Case No. CD-CPC-2022-00098

6200 E. Bannister Road
The Trails at Bannister

Rezoning to UR
Development Plan (Residential) & Preliminary Plat

Pedestrian Safety

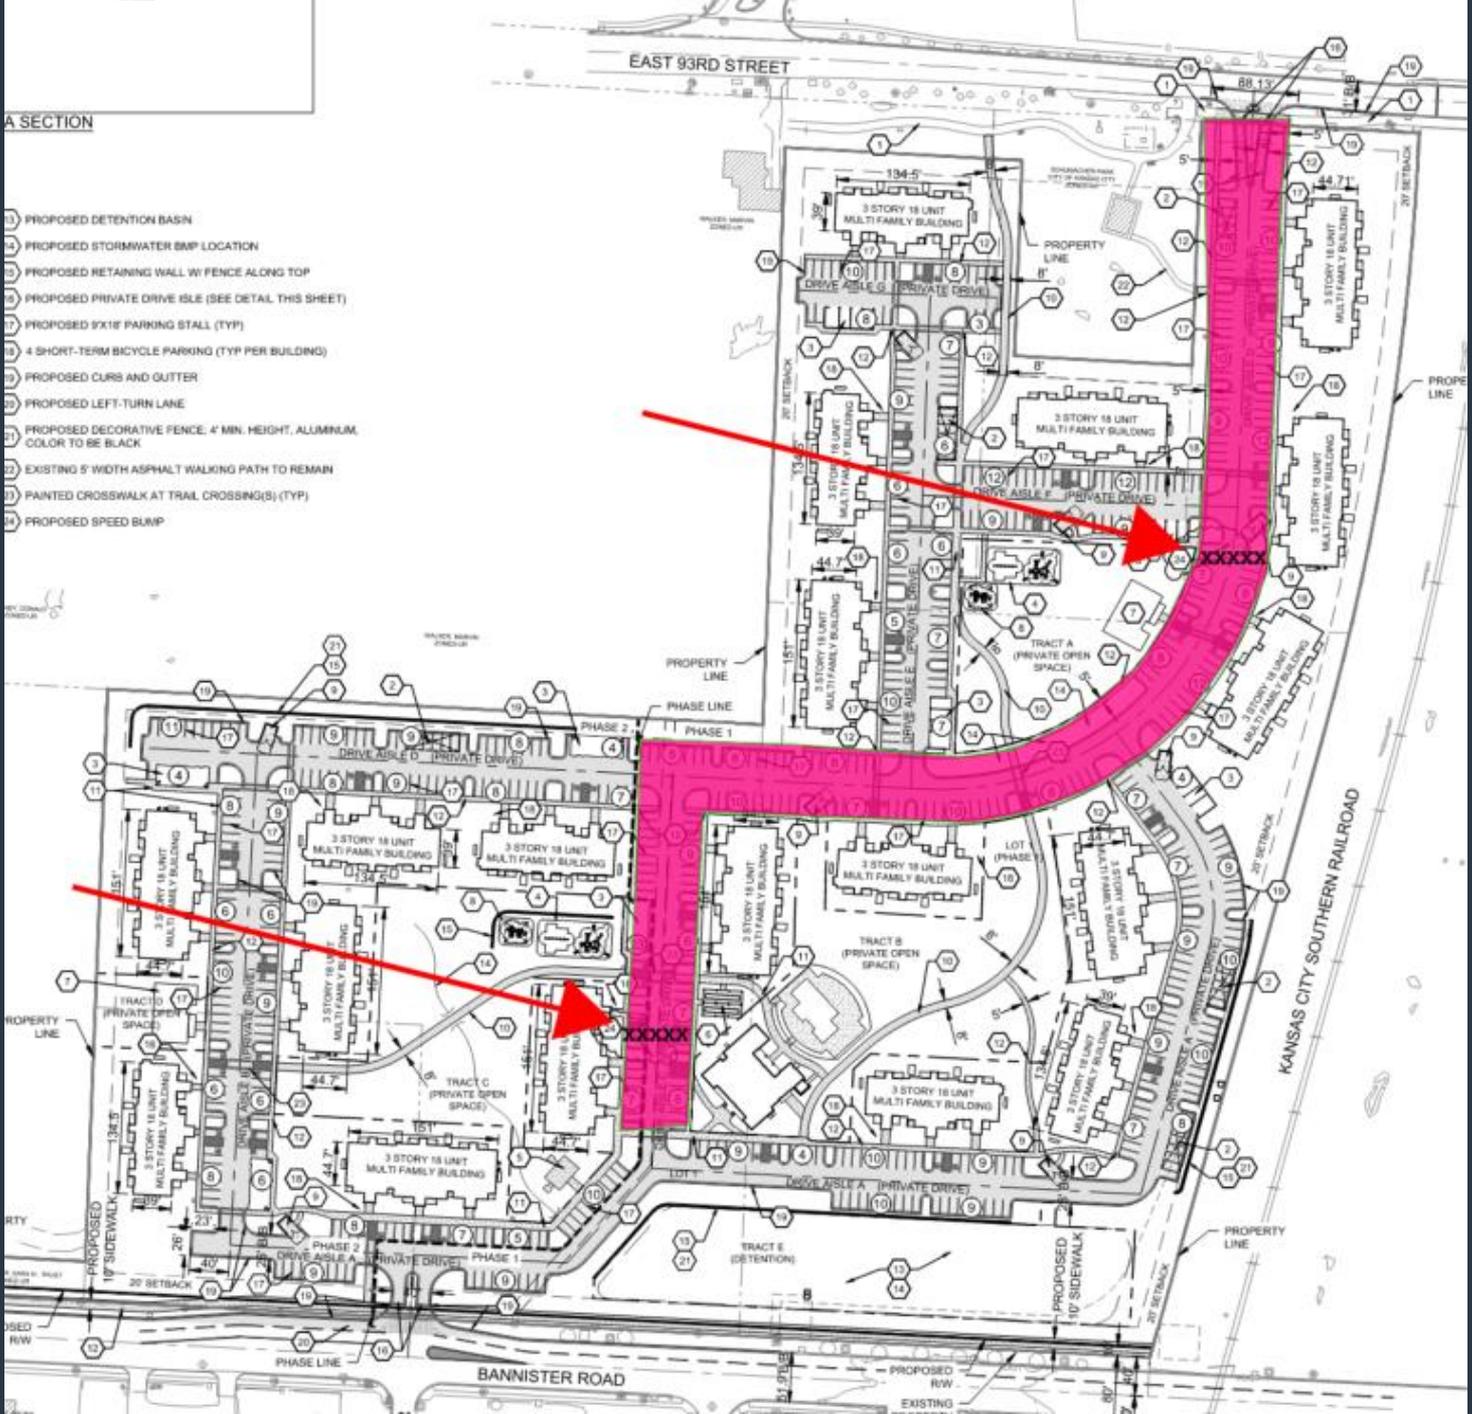
Staff is seeking the removal of condition #7

Revise plans to show raised pedestrian crossing at building #7 and between buildings #19 and #8 (88-450-03-C) prior to ordinance request.

The applicant stated that they cannot provide a raised pedestrian crossing due to accessible parking being in the area, the developer will install speed bumps near the two locations.

Pedestrian standards will be reviewed with each final plan for Phase I and Phase II
